# SERVICE BULLETIN

#123  
Supplement to #24

Subject: CLUTCH ASSEMBLY

Description: PEDAL AND LINKAGE ADJUSTMENT

ILLUSTRATION FOR PEDAL AND LINKAGE ADJUSTMENT

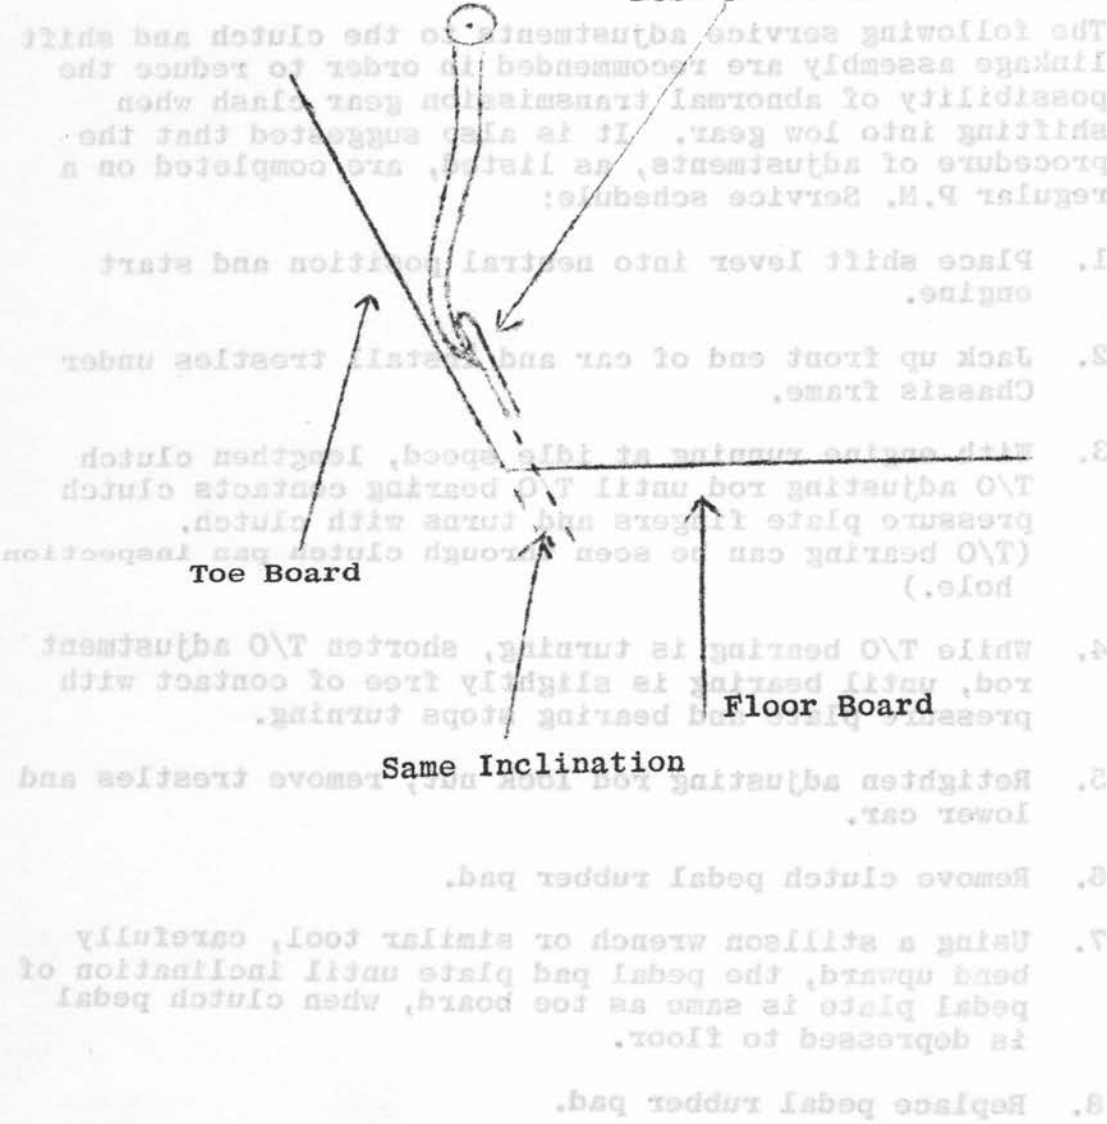
Description: PEDAL AND LINKAGE ADJUSTMENT  
Bend pedal metal pad "up"

1. Place shift lever into neutral position and start engine.
2. Jack up front end of car and install trestles under Chassis frame.
3. With engine running at idle speed, loosen clutch T/O adjusting rod until T/O bearing contacts clutch pressure plate fingers and turns with clutch. (T/O bearing can be seen through clutch inspection hole.)
4. While T/O bearing is turning, shorten T/O adjustment rod, until bearing is slightly free of contact with pressure plate fingers and bearing stops turning.
5. Retighten adjusting rod lock nut, remove trestles and lower car.
6. Remove clutch pedal rubber pad.
7. Using a stiffen wrench or similar tool, carefully bend upward, the pedal pad until inclination of pedal plate is same as toe board, when clutch pedal is depressed to floor.
8. Replace pedal rubber pad.
